5. Floor dropped by access door
6. All surface water drainage to receive Building Control approval.
AMENDMENT
AMENDMENT
Terrace
PLANNING SERVICES
ADUR & WORTHING
PLAN
AWDM/1512/16
DATE
23 JAN 2017
VALID
Date: Aug. 2016
Scales: As shown
Paper size: A3
Dwg No: BH-248-04/B

Drawing title: Proposed rear roof terrace and front Juliet balcony
Address of works: 248 Brighton Road, Lancing
Unit 1
Gosling Croft Business Park
Clapham Worthing
Long Furlong
West Sussex BN13 3UT
architectural & quantity surveying services

PROPOSED SECOND FLOOR PLAN 1:50
PROPOSED SOUTH ELEVATION 1:100
PROPOSED NORTH ELEVATION 1:100
PROPOSED EAST ELEVATION 1:100
1:50 Scale Bar
1:100 Scale Bar
1m 2m 3m 4m 5m 6m
Planning Revisions – B – 23rd January 2017

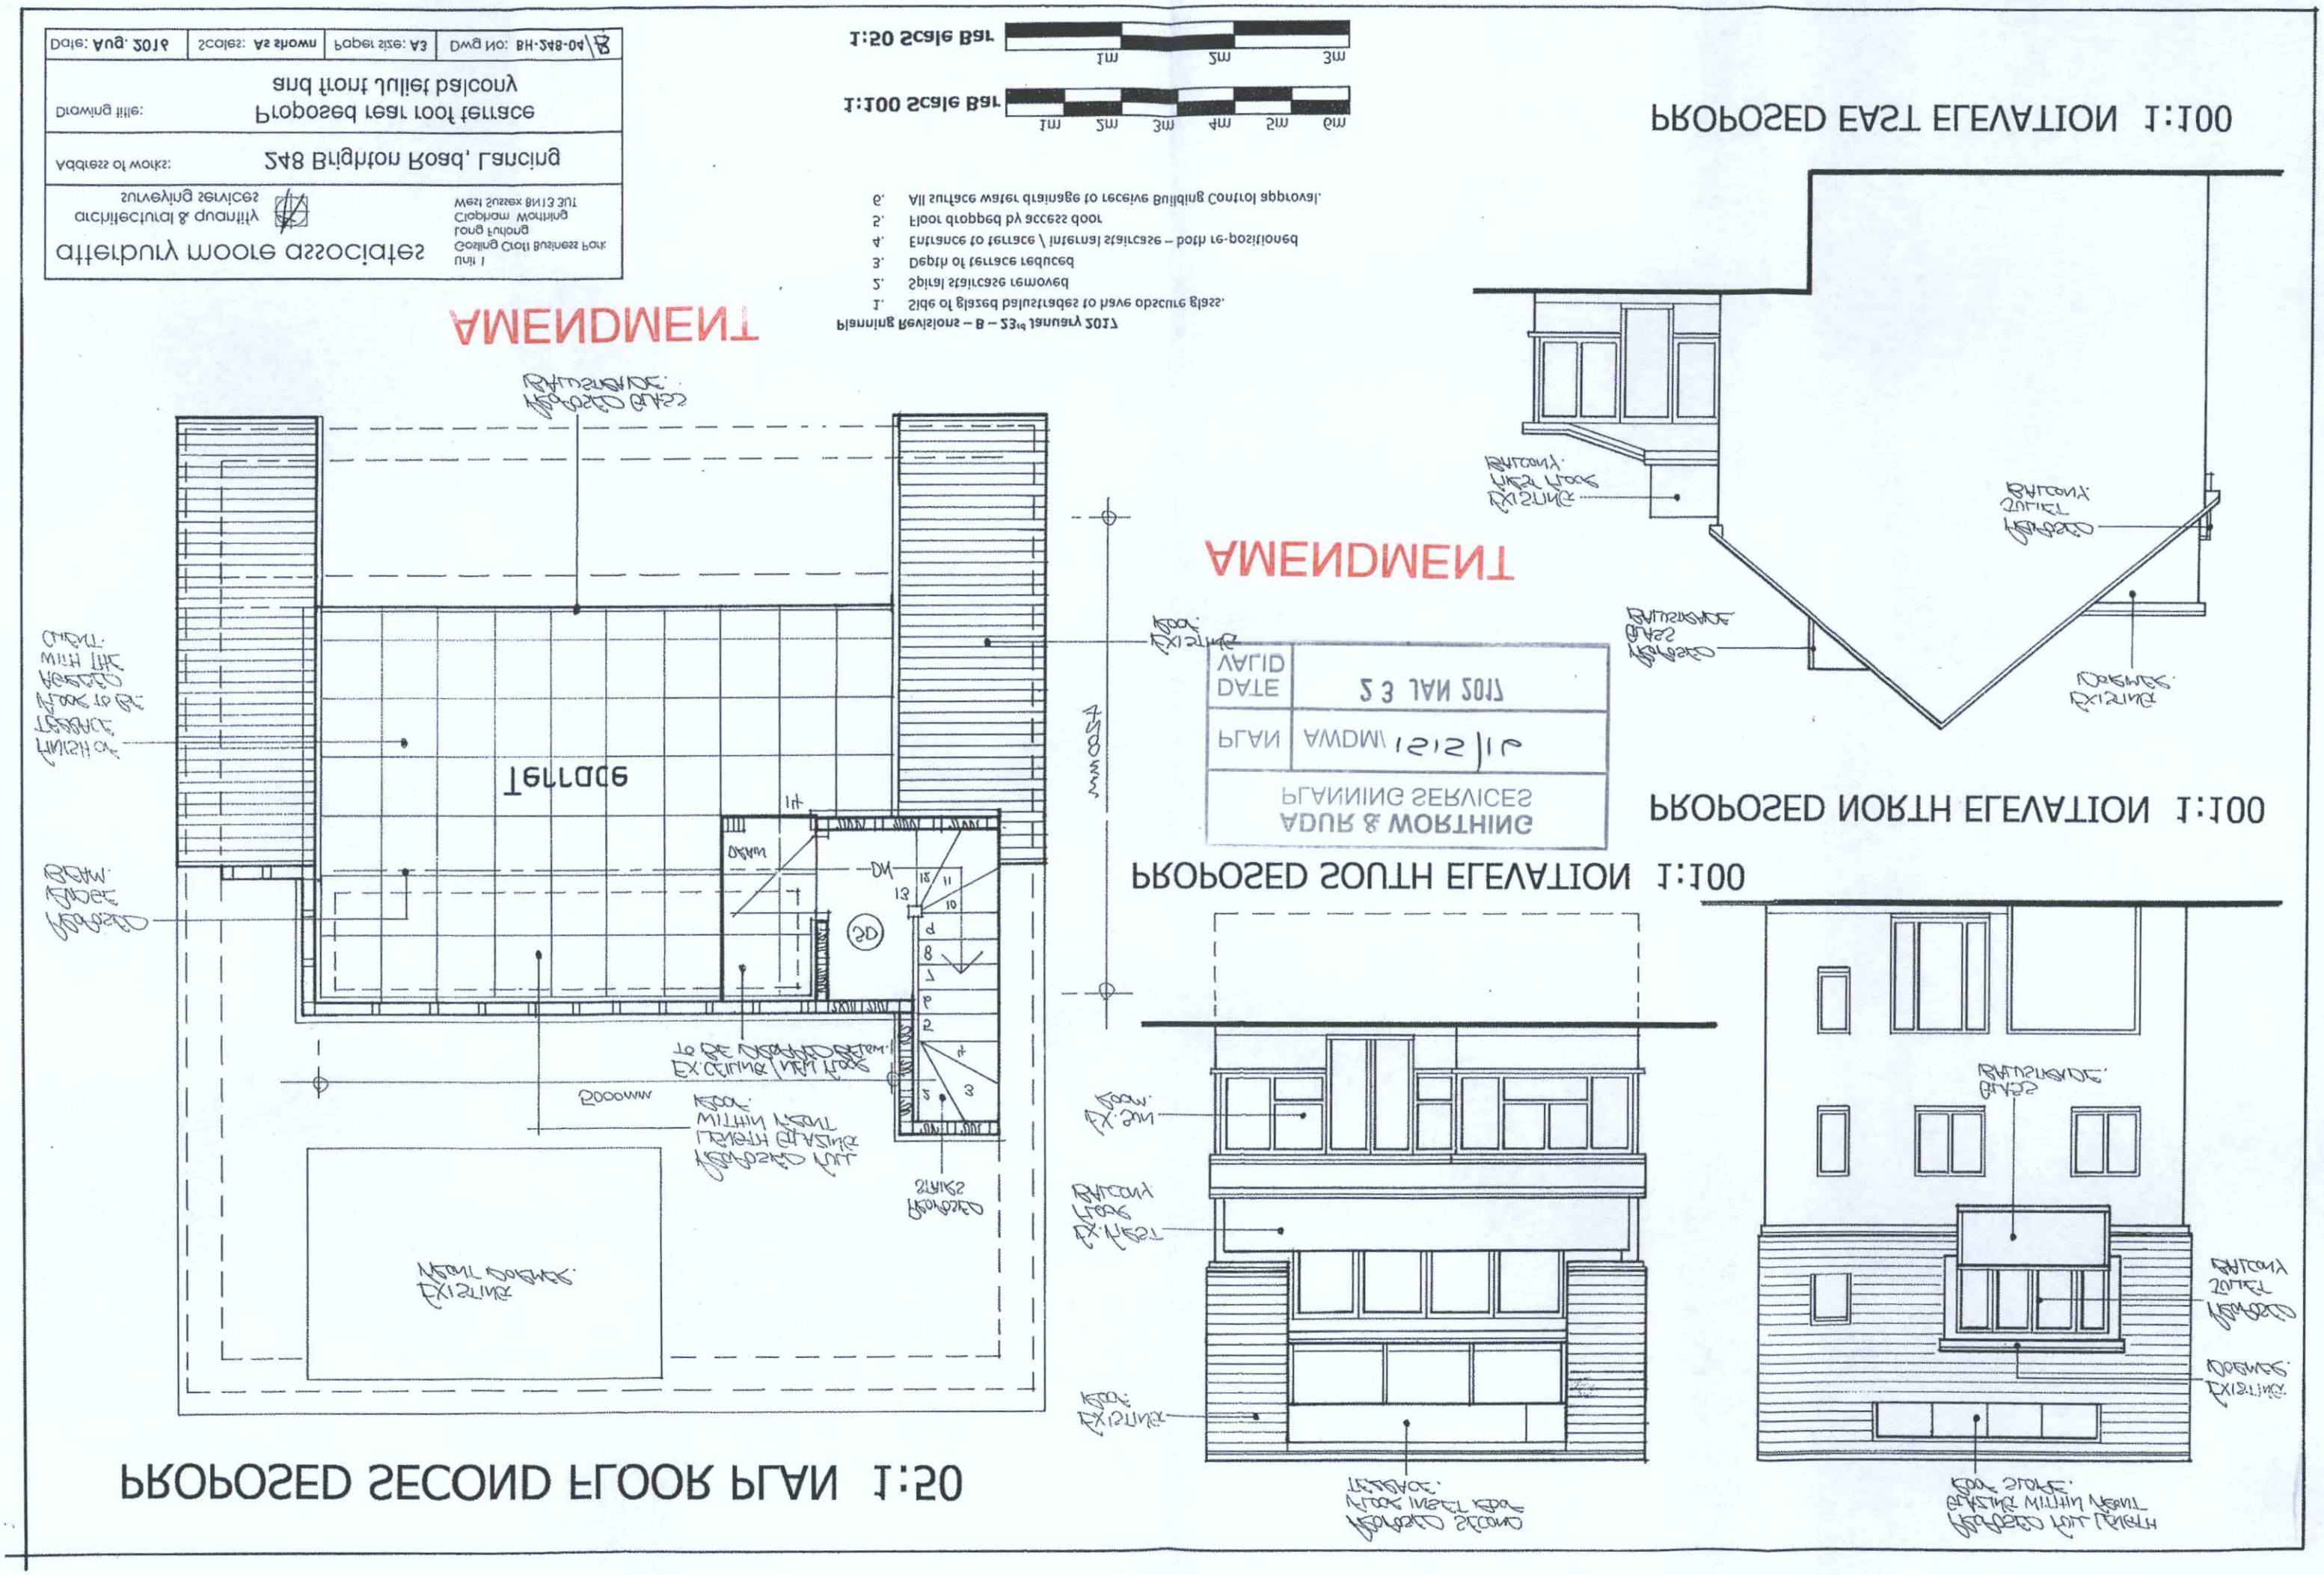
1. Side of glazed balustrades to have obscure glass.
2. Spiral staircase removed
3. Depth of terrace reduced
4. Entrance to terrace \ internal staircase – both re-positioned
